**ADDENDUM NO. 1
06/04/26**

SPECIFICATION NO. 26-11757-C

CITY OF BERKELEY

**SANTA FE TRACKBED TO PARK CONVERSION
New Community Gardens, Dog Park, and Playground**

5 HUGELKULTUR BED
L4.10 3/4" = 1'-0"

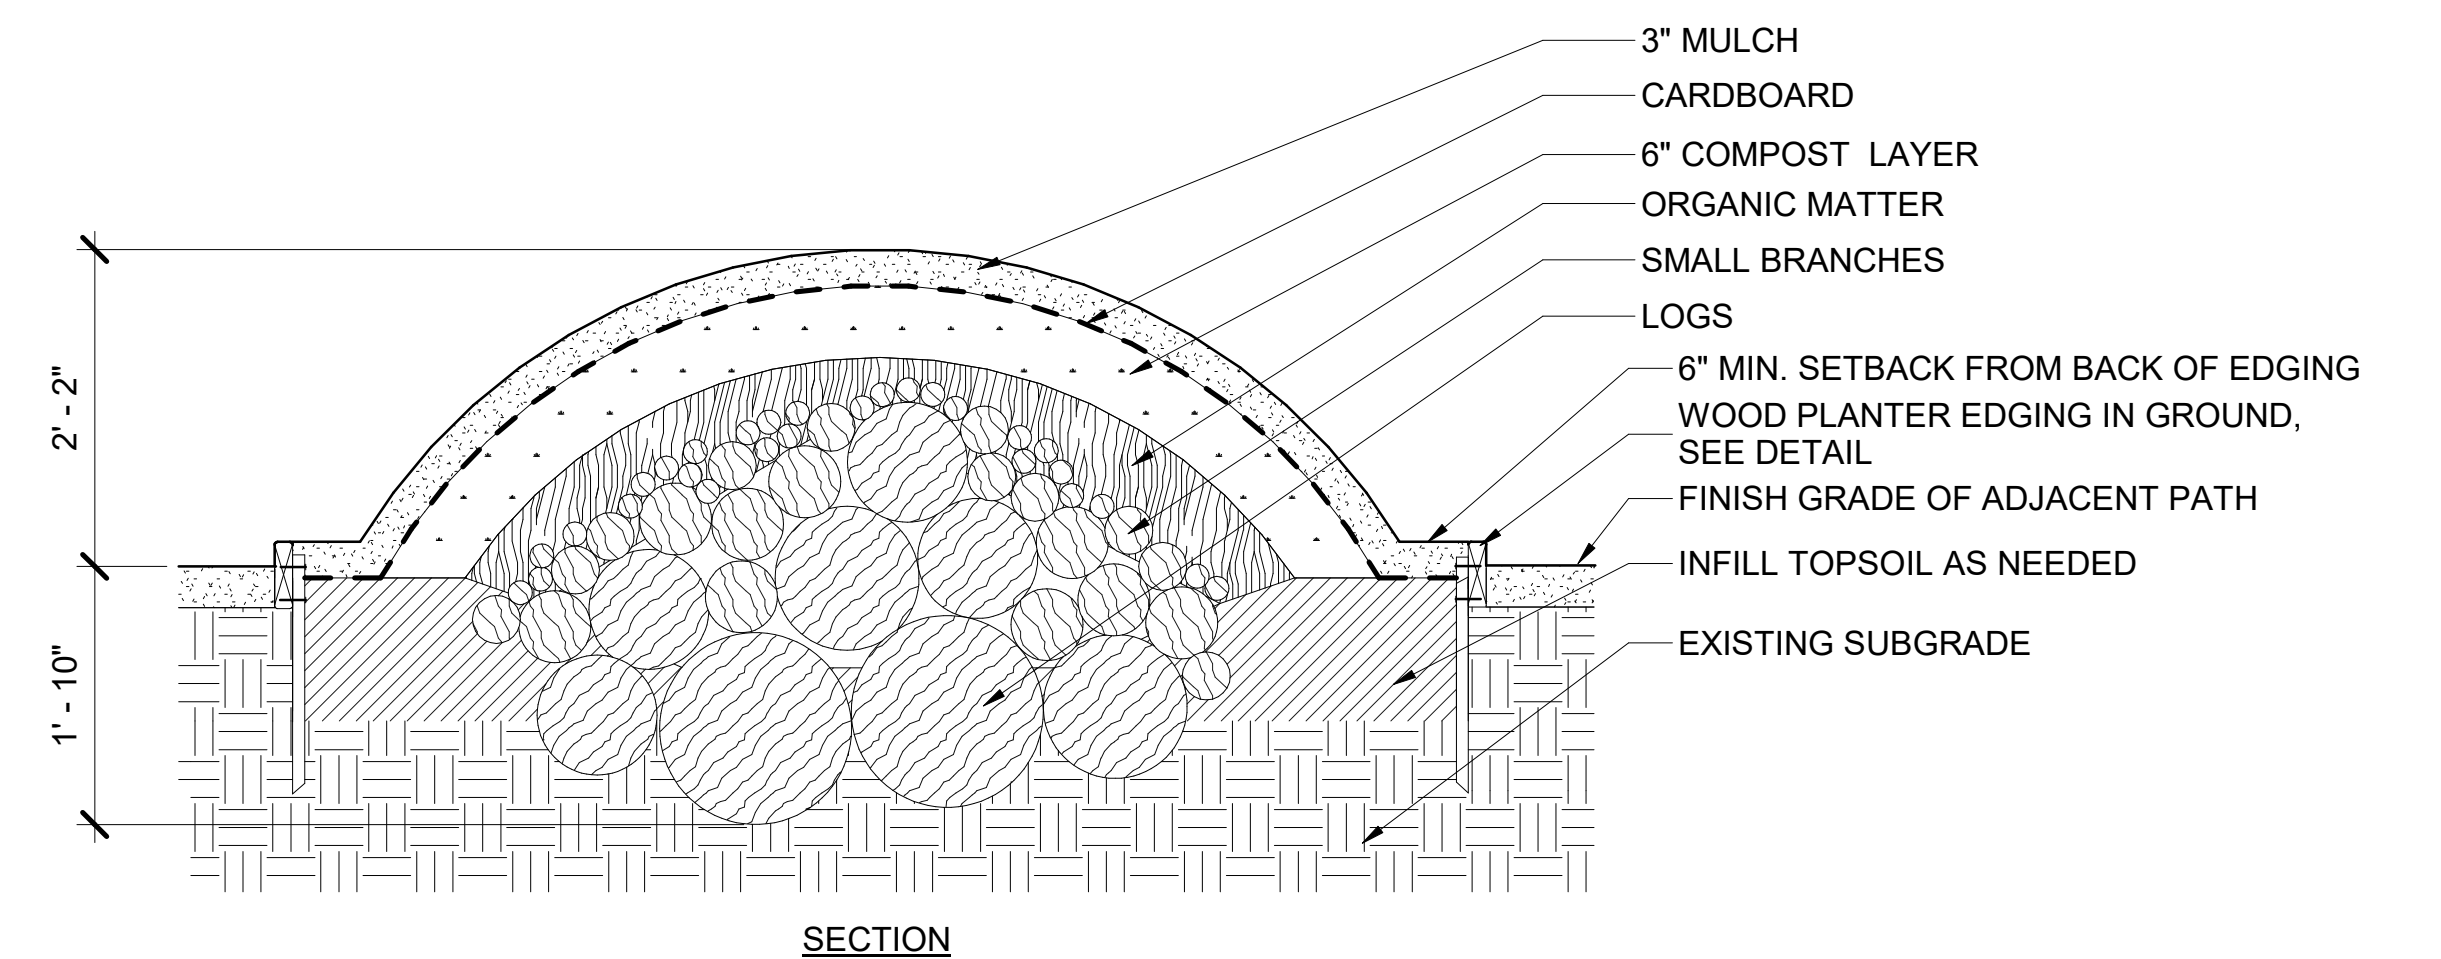
32. Please provide the required material and installation depth for organic matter to be installed at the Hugelkultur bed per Detail 5/L4.10.

Response Organic matter shall be leaves, grass clippings, unfinished compost per detail 5/L4.10. Install depth shall be 6”.
